# PRODUCT CHANGE | Drive Set for 28mm DC motor in 2.0" Ribbed Tube

DISCONTINUED PRODUCT	REPLACEMENT PRODUCT	CHANGES MADE	
			YES	NO
DESCRIPTION.	Drive Set for 28mm DC motor in 2.0" Ribbed tube	Drive Set for 28mm DC motor in 2.0" Ribbed tube	<input type="checkbox"/>	<input checked="" type="checkbox"/>
CODE.	MTDR-28-2	MTDR-28-2	<input type="checkbox"/>	<input checked="" type="checkbox"/>
PACK SIZE.	100	100	<input type="checkbox"/>	<input checked="" type="checkbox"/>
PRICE.			<input type="checkbox"/>	<input type="checkbox"/>
IMAGE.			<input checked="" type="checkbox"/>	<input type="checkbox"/>
USE WITH.	28mm Automate Motors, 2" Ribbed Tube		<input type="checkbox"/>	<input checked="" type="checkbox"/>
TRANSITIONING.	March 2020

### PRODUCTION / INSTALLATION IMPROVEMENTS

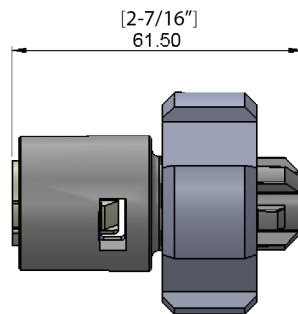
- Single piece drive design (reduced assembly time)
- Reduced minimum blind width by 39mm [1-9/16"]

- Soft outer body for silent operation
- Improved torque capacity
- Improved resistance to heat degradation
- Reduced cost
- Reduced minimum width
- Rubberized ribs grip tube for a better fit
